Development Review Committee (DRC) Meeting

The applicant is requesting approval of an Overall Development Plan for 126 Townhome units off of East Highbanks Road.

OVERALL DEVELOPMENT PLANS FOR Highbanks Townhomes

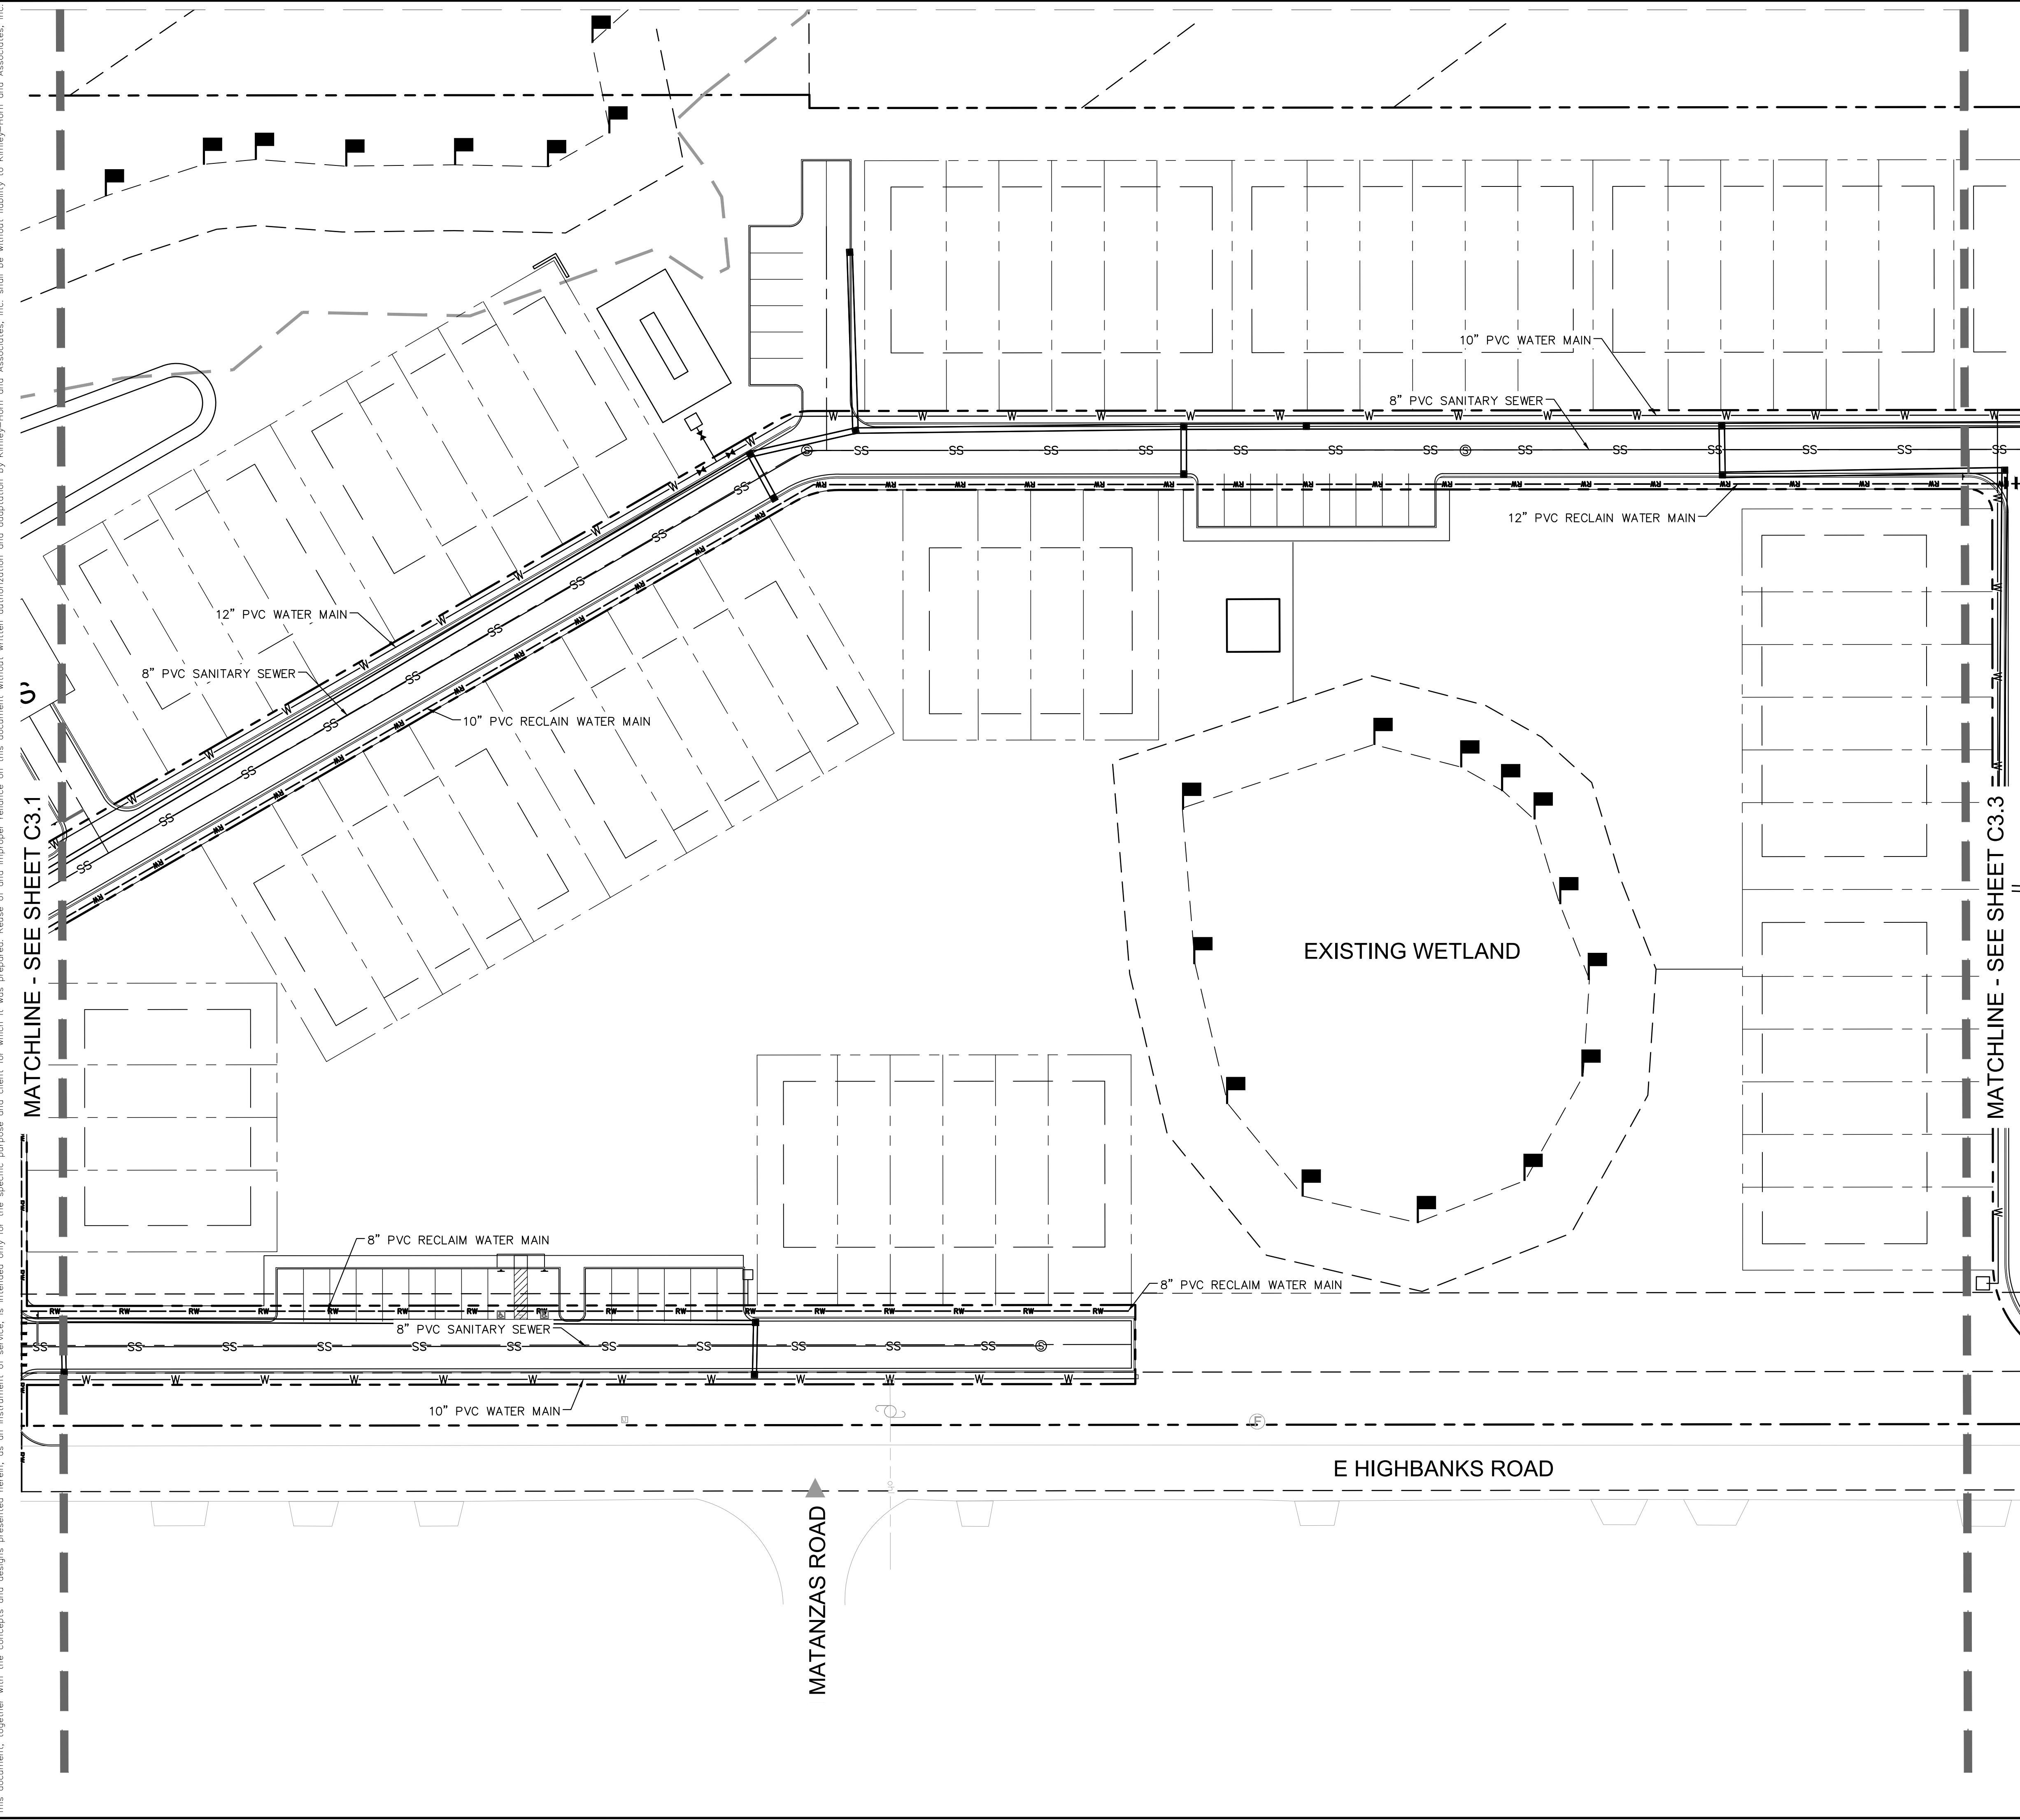
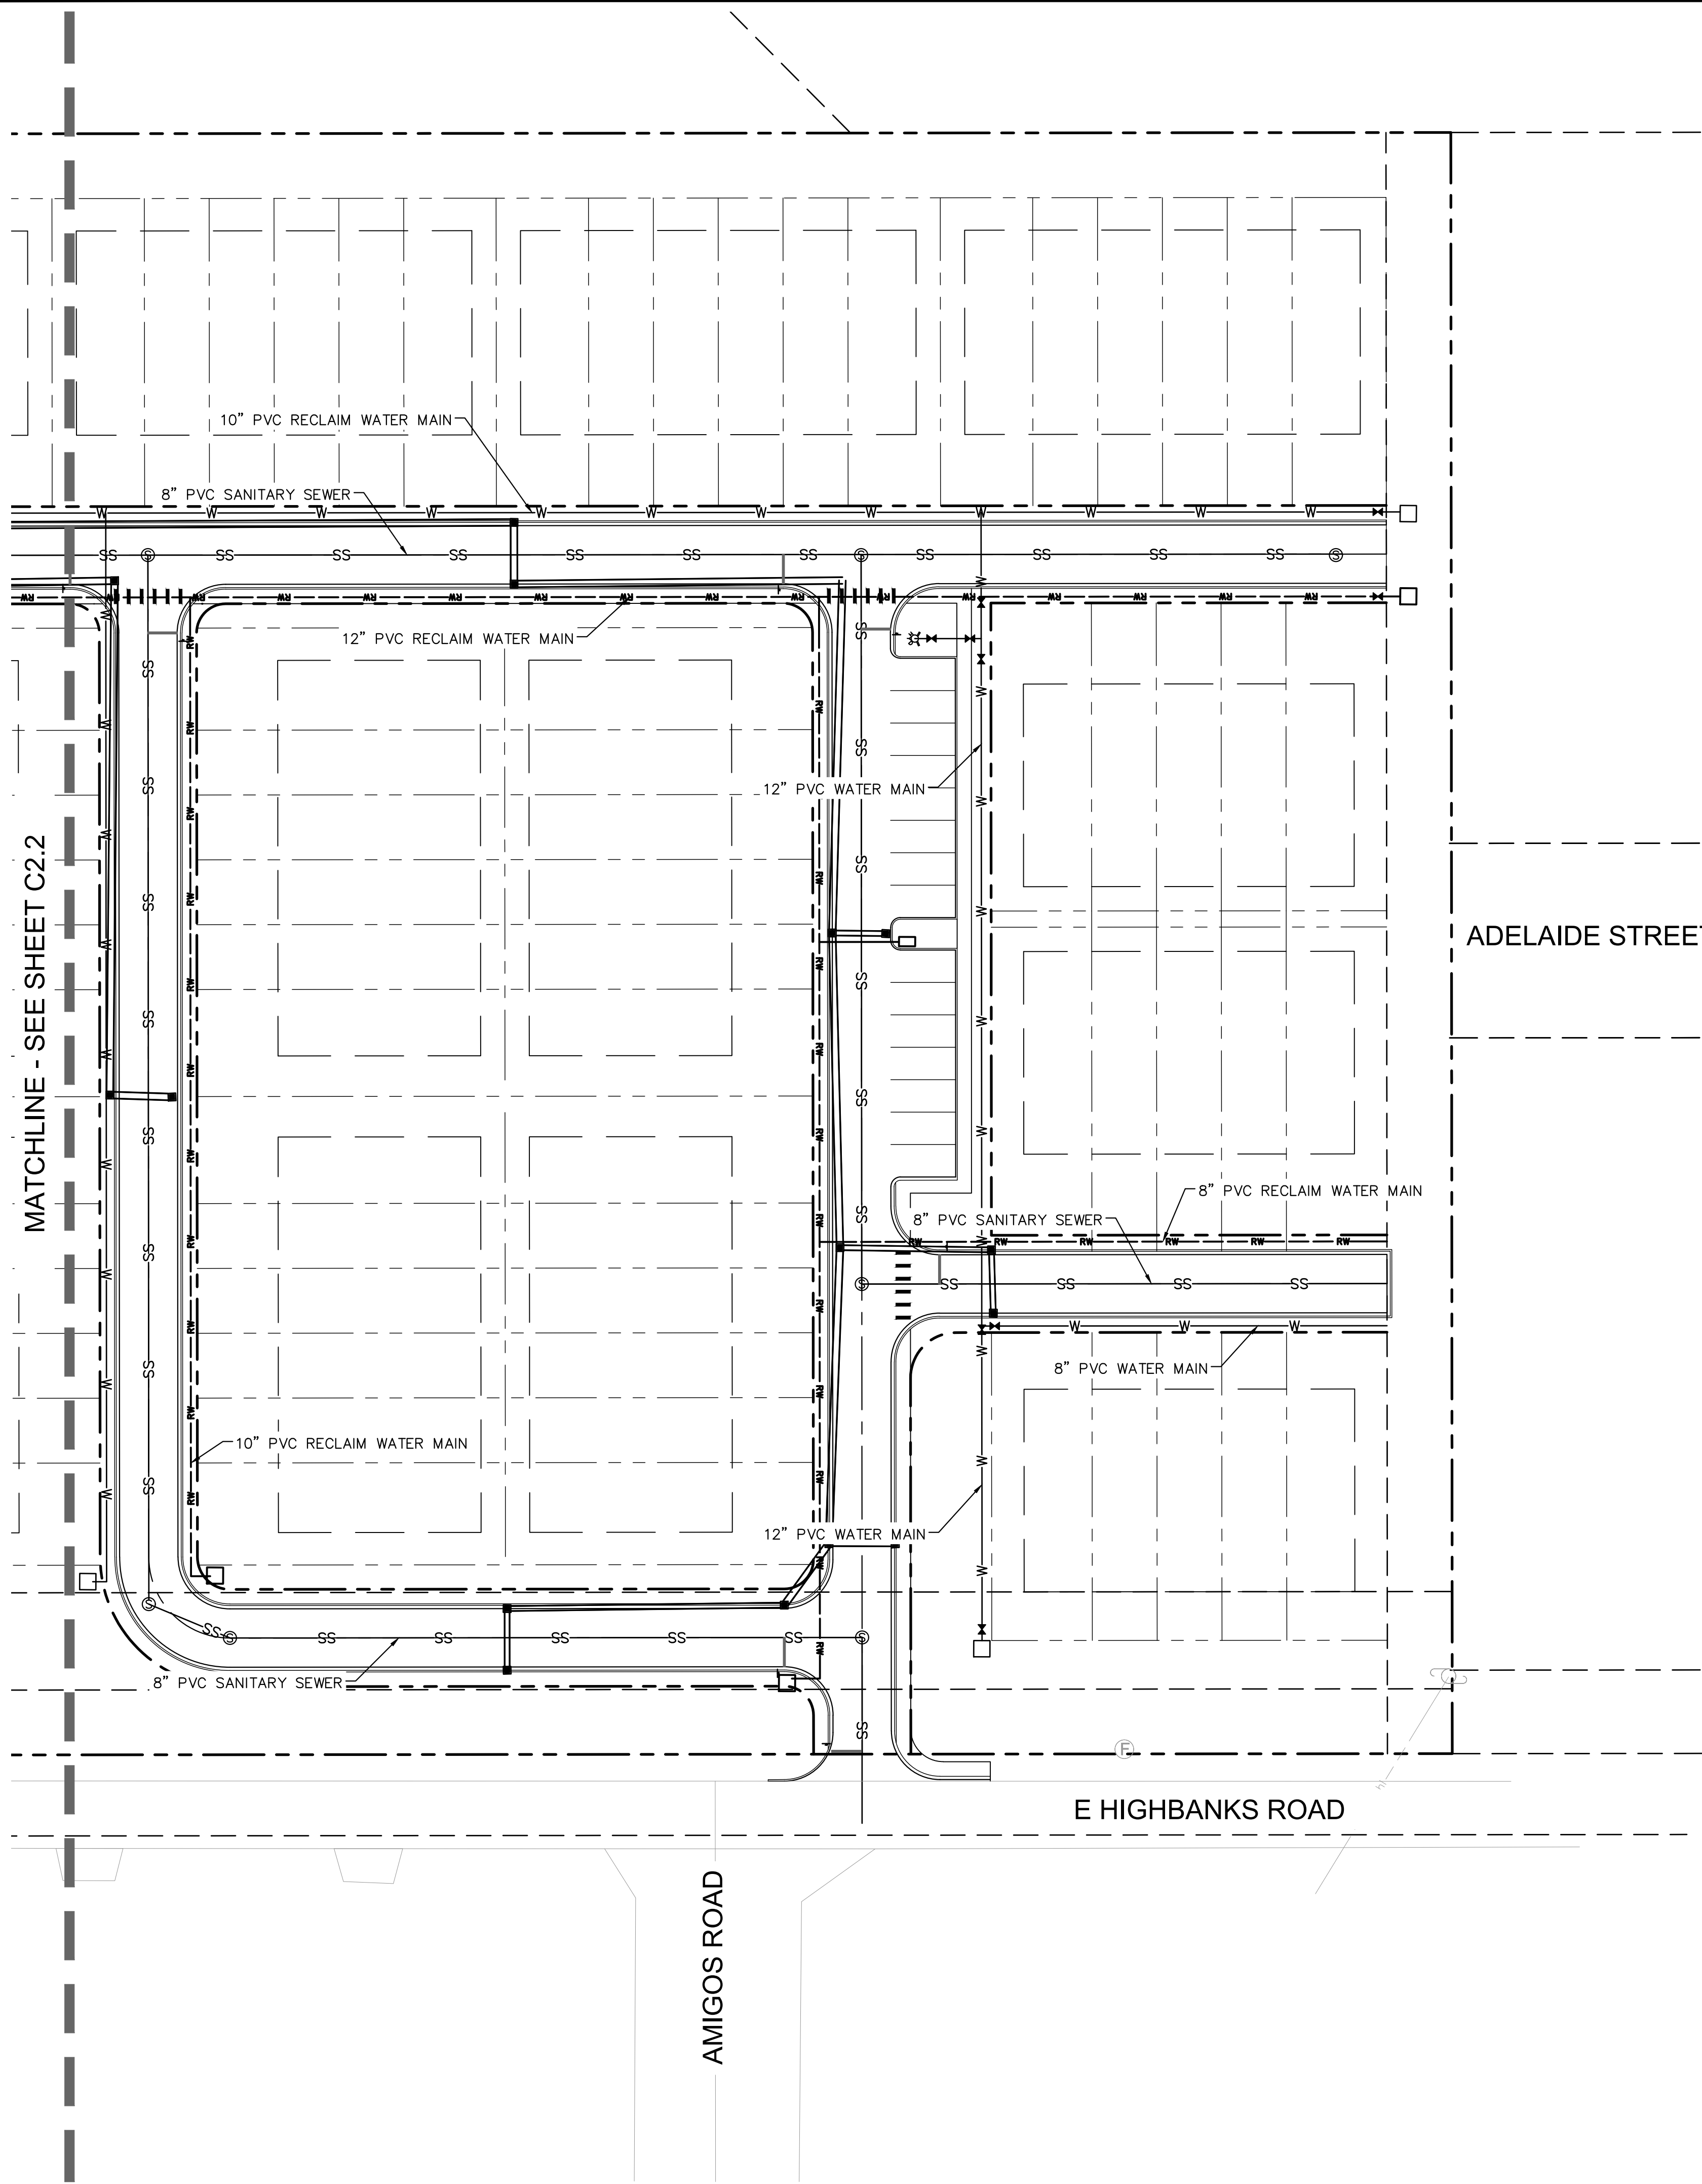
1. Water line are shown on plans, but doesn't show any Fire Hydrants placement. Provide details on Fire Hydrants and Fire Flow requirement per the Florida Fire Prevention Code 7th ED of NFPA 1 Chapter 18 Section 18.1.3.2 and 18.4 for review.
 2. Page C1.0 shows dead-end roads. Provide details on distance length of roadways. The Florida Fire Prevention Code 7th ED of NFPA 1 Chapter 18 Section 18.2.3.5.4.
 3. Provide CAD Drawings for turning radius. The Florida Fire Prevention Code 7th ED of NFPA 1 Chapter 18 Section 18.2.3.5.3.
 4. Plans don't show any Fire Lanes. Provide details to meet the Florida Fire Prevention Code 7th ED of NFPA 1 Chapter 18 Section 18.2.3.6.3.
-
